Product Support Bulletin 2009-023A

Maintenance of Way ~ Work Equipment Bulletin NOTE: THIS BULLETIN REPLACES PSB 2009-023

DATE:	August 6, 2009		
SUBJECT:	Stauff Quick Coupler Recall – 10288608	8	
RATING:	X DIRECTIVE (Action is required)		ALERT (Potential Problem)
	INFORMATION (Action is optional)		PRODUCT IMPROVEMENT (Enhance Product)
MACHINE MODEL(S):	Anchor Applicator Anchor Remover Auto Lift – Rail Lifter BAAM – Bulk Automatic Anchor Machine CGS – Curve Gang Spiker C-CX Hammer Conversion CX Hammer Grabber Conversion M7 Ballast Regulator/Snow Fighter NSCA – Spring Clip Applicator NVCAR – V-Clip Applicator/Remover Quad Drill PSS – Production Screw Spiker SP2R – Dual Rail Spike Puller SS Spiker – Small Spiker Super Claws – Single Sided Spike Puller Super Claws Conversion TRIPP – Tie Exchanger		
SERIAL

Figure 1
10288608 Stauff Quick Coupling with female JIC swivel nut threads. This is the only Stauff Quick Coupling supplied to Nordco that is subject to this recall.

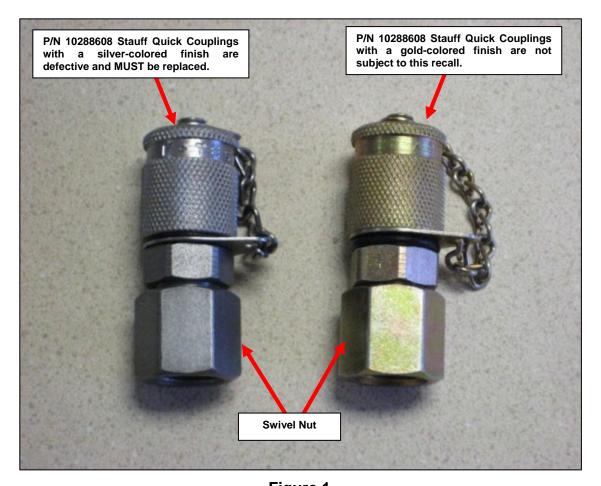
Some of the Quick Couplings supplied after March 1, 2008 have a retaining ring groove that is out of tolerance. This defect could cause the body of the coupling to separate from the swivel nut when under hydraulic pressure and become a projectile when it separates. THIS CREATES A SIGNIFICANT RISK OF PERSONAL INJURY OR DEATH AND PROPERTY DAMAGE.

ALL MACHINES IN THE ATTACHED LIST MUST BE INSPECTED IMMEDIATELY TO DETERMINE IF THERE ARE DEFECTIVE COUPLINGS ON THE MACHINE. Defective couplings can be identified by the silver finish. Couplings that have a gold-colored finish were supplied prior to March 1, 2008 and are not subject to this recall, however Nordco recommends that all Couplings on a given machine be replaced even if only one is defective. Nordco will supply enough Couplings to replace all of the fittings used on the affected machine. See the table on Page 4 and the photos on Page 6 for locations of the Couplings.

ALL DEFECTIVE COUPLINGS MUST BE REMOVED IMMEDIATELY AND REPLACED WITH CAPS UNTIL THEY CAN BE REPLACED WITH NEW COUPLINGS SUPPLIED BY NORDCO. Contact the Nordco Service Department at 1-800-445-9258 to order replacement couplings. Please have the machine serial number(s) available when calling. Nordco will issue a Return Authorization Number at the time the order is placed. ALL DEFECTIVE COUPLINGS MUST BE RETURNED TO NORDCO. Pre-paid return envelopes will be provided with each order for your convenience.

Figure 2
Replacement Couplings will be identified with an "R" stamped in the Coupling as shown.

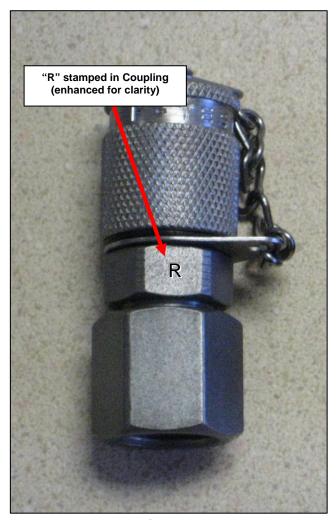
Replacement Couplings will also have a silver-colored finish but will be identified with a capital letter "R" stamped into one of the wrench flats of the Coupling body. See Figure 2 on Page 5.
